# Investigation of IEC 15 mm Bayonet cap/holder systems

Search for Substitute solutions  
(focus on PY21W with fit system BAU15s)

Cor Versluijs  
2018-03-12

# Evaluation proposal Valeo (reference TFSR-01-10)

# Examination Valeo Proposal:

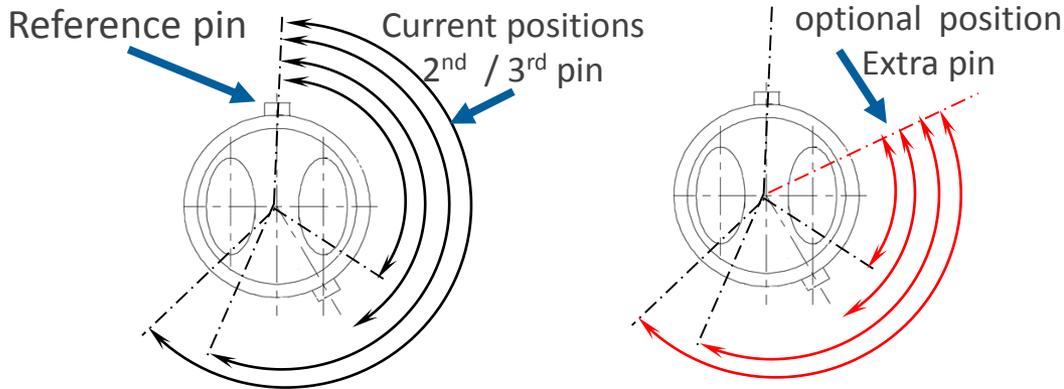
- Angular offset from Reference pin (estimated from input):
  - A slot at +70°, 80°, 90° 100° or 110° clockwise holder top-view (see next slide)
- All\* current Automotive 15 mm Bayonet fits with this extra pin added,
- All\* “Non-LED” automotive fit-types to be checked:
  - “reference” Cap-pin in “new Holder-Slot”
  - “non-reference” Cap-pin in “new Holder-Slot”
- **close fit need to be prevented:**  
Due to tolerances in the fit system, the basic difference in “angular step” for the pins in this system should be 20° or more to enable a clear discrimination in the fit-system

\* the BAX system is not taken into account for it's different pin lengths is not a real discriminator in the BA15; it just fit's and there is no adequate holder definition in IEC
